9.2 NO. 4 (LOT: 235; D/P: 1237) ETHEL STREET, NORTH PERTH - PROPOSED TWO GROUPED DWELLINGS

RECOMMENDATION:

TITLE
Proposed Ground Floor Plan - Rear Lot

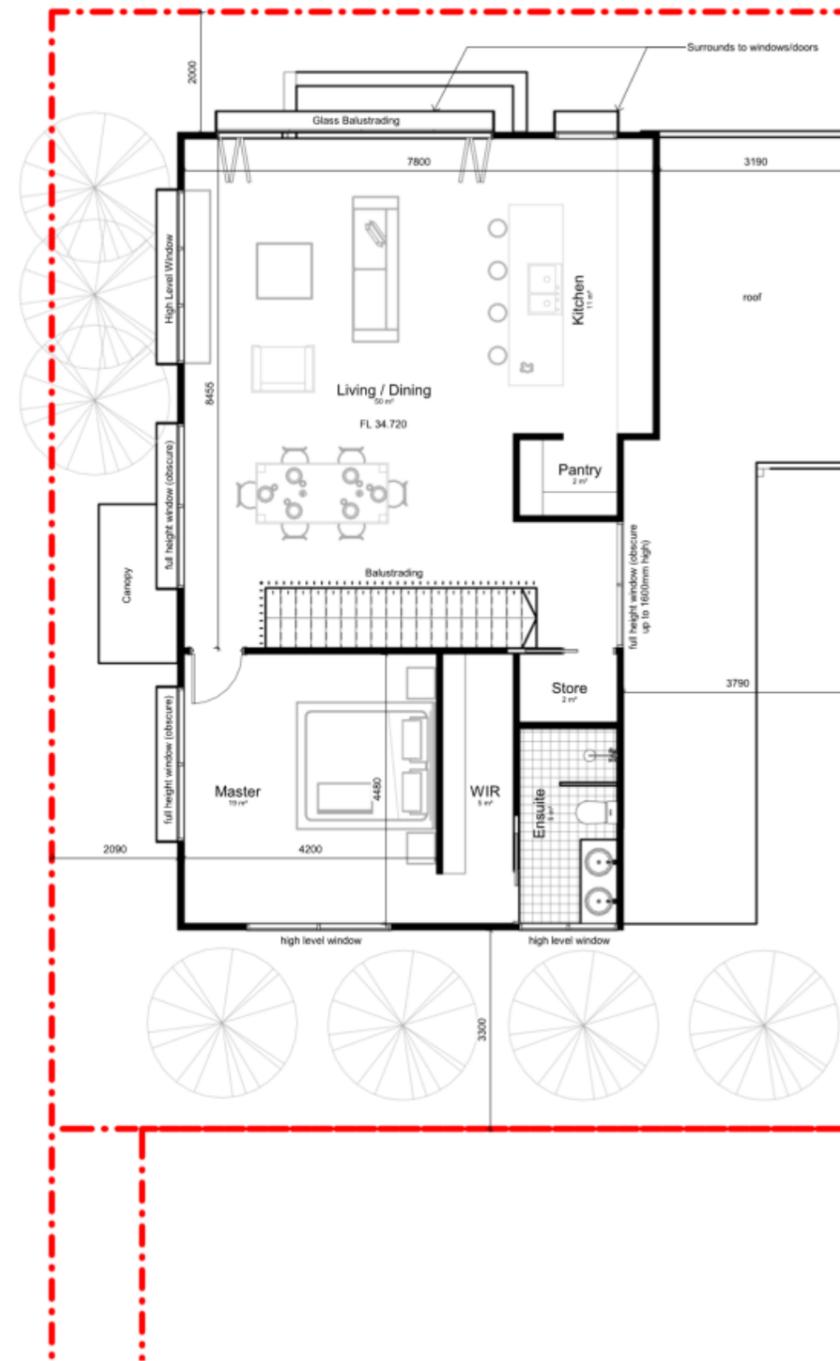
After the 29 March 2022 Council Briefing Session, the applicant revised the plans to provide 1.6 metres high obscure glass balustrading to the opening of the living/dining room on the first floor of Unit 2 facing the right of way. The screening treatment would address perceived overlooking to neighbouring outdoor living areas and open space, and to increase the privacy of the occupants to Unit 2.

| Rev | Description | By | Date |
|-----|---|-----|----------|
| 10 | Trees added and 1.6m high obscure glass balustrading shown. | Swi | 30/03/22 |

| DRAWING NUMBER A012 | REV 10 | |

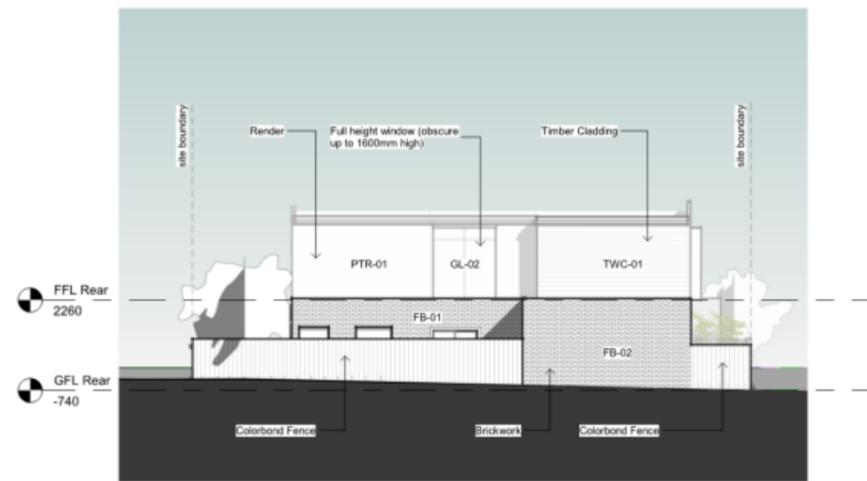
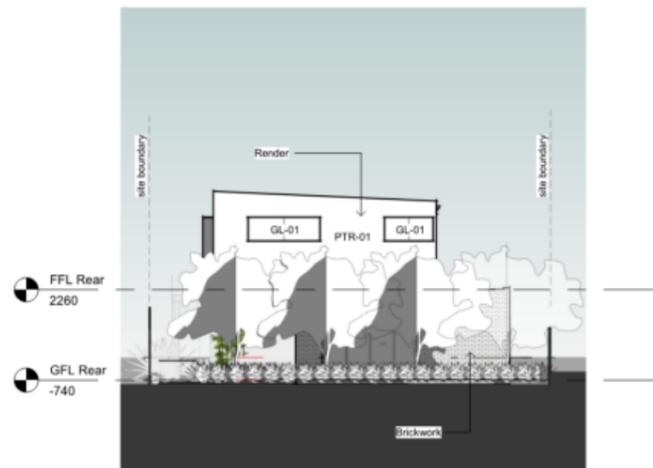
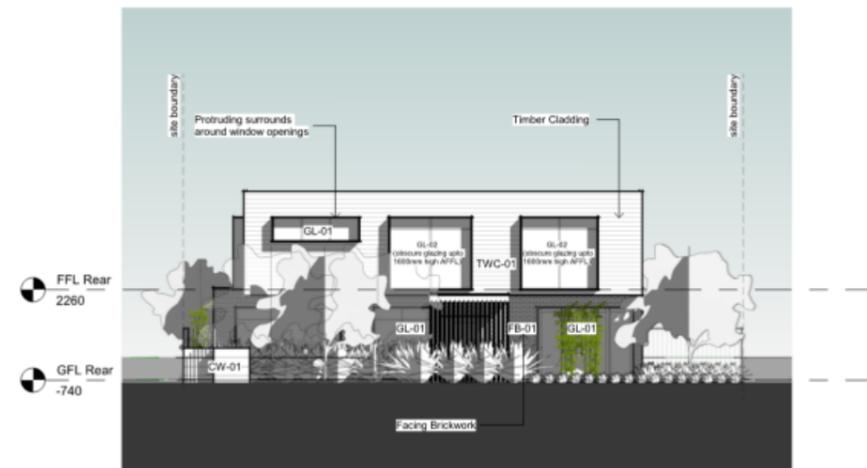
| Rev | Description | By | Date |
|-----|---|-----|----------|
| 10 | Trees added and 1.6m high obscure glass balustrading shown. | SWI | 30/03/22 |

Landscape Plan - Tree Canopy Coverage

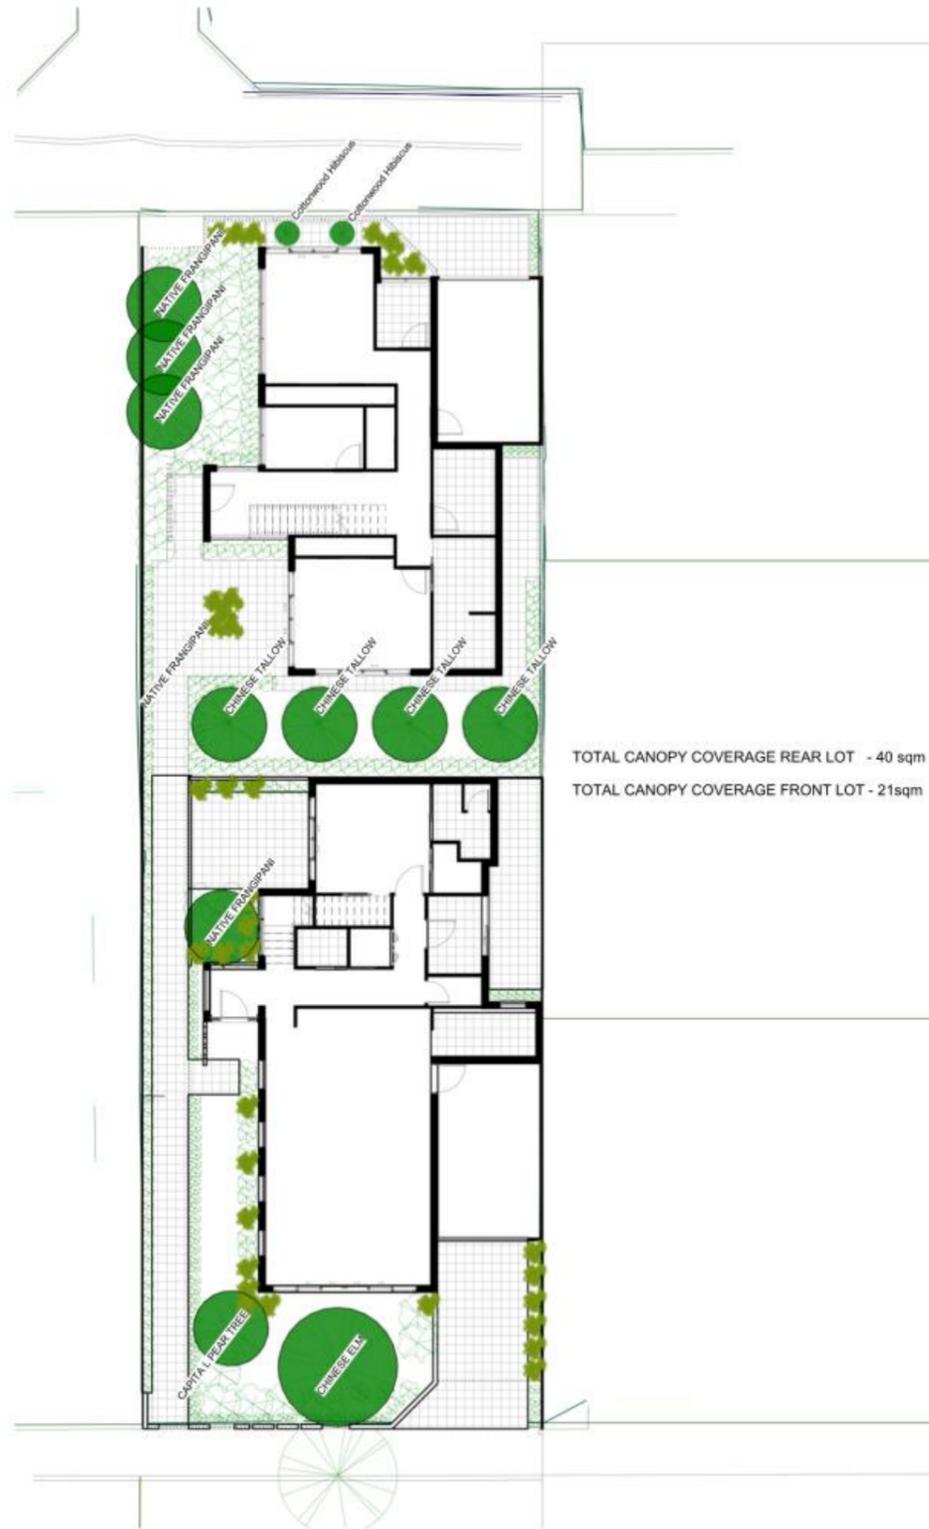
The Built Form Policy deemed-to-comply standard requires 30 percent of lots to be provided as canopy coverage at maturity. Unit 1 initially proposed 14.7 percent canopy coverage at maturity. After the 29 March 2022 Council Briefing Session, the applicant submitted amended plans with an additional Capital

Pear tree in the front setback area of Unit 1. Unit 1 would now provide 18.6 percent canopy coverage at maturity.

| Rev | Description | By | Date |
|-----|---|-----|----------|
| 4 | Tree added | SWI | 30/03/22 |
